GRANTS LITHIUM PROJECT

Environmental Impact Statement

Additional Information

Figure 3-1. Location of waste characterisation drill holes in relation to original pit and extended pit

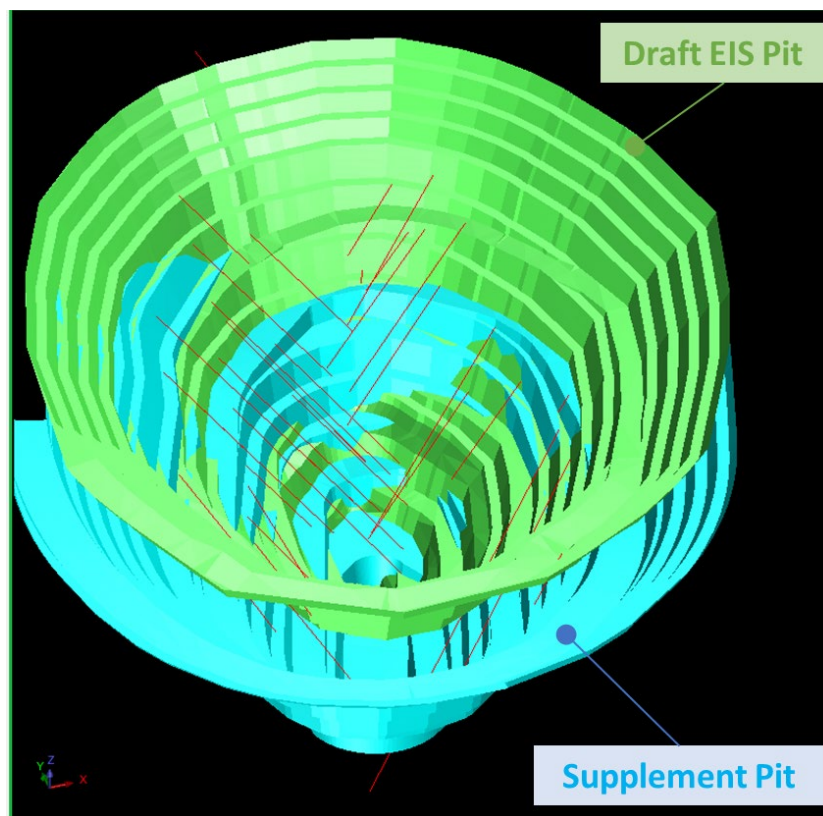
The increase in pit depth from 180 m to 200 m and associated changes to the significance of impacts, especially on Terrestrial Environment Quality and Inland Water Environment Quality, have not been sufficiently addressed in the Supplement. No further information or discussion about the additional waste rock (56% increase in volume) characteristics was provided to assess the significance of the pit extension.

From the data presented in the Draft EIS, it is unclear where drilling samples have been undertaken and how the results correlate with the expanded pit shell and data provided in the Supplement.

- Provide information to justify that the waste rock geochemical characterisation is consistent with relevant guidelines for the characterisation of acid, metalliferous and/or saline drainage, and discuss the scientific confidence in the findings.
- Provide information about the location of each drill bore number in relation to the extended pit shell, preferably in 3D.

Figure 3-1 depicts the original pit shell (green) and the expanded pit shell (aqua), showing that most of the pit expansion occurs to the south. The image illustrates that in some areas, in particular the northern and western portions of the pit, the wall of the extended pit shell sits inside the wall of the original pit shell.

The red lines on Figure 3-1 depict drill holes from which samples were collected for waste characterisation, from the hole collar at the surface, down to the deepest point from which a sample was collected. The holes are drilled on an angle from the outer edges of the pit shell towards the mineral resource, which is vertical and runs along a north-south axis through the centre of the pit (refer Figure 3-1). The holes have not been labelled on the image as it is difficult to clearly illustrate these 3D data in 2D format; however, Core would be happy to provide an on-screen 3D presentation to the relevant NT EPA and/or DPIR staff if required.

In the southern portion of the pit, Figure 3-1 shows a number of drill holes that extend into the expanded pit shell. Waste characterisation samples were collected from six of these holes as part of the routine sample collection undertaken during the last round of exploration drilling in late 2018. The samples are from downhole depths between 38 m and 136 m. Whilst none of these samples are from the deeper parts of the extended pit shell, the waste characterisation program did characterise six samples collected from downhole depths greater than 180 m. Table 3-2 provides details of the sample locations and geochemistry for waste characterisation samples that, given the homogeneity of the geology, should be indicative of the characteristics of the waste rock in the expanded pit shell.
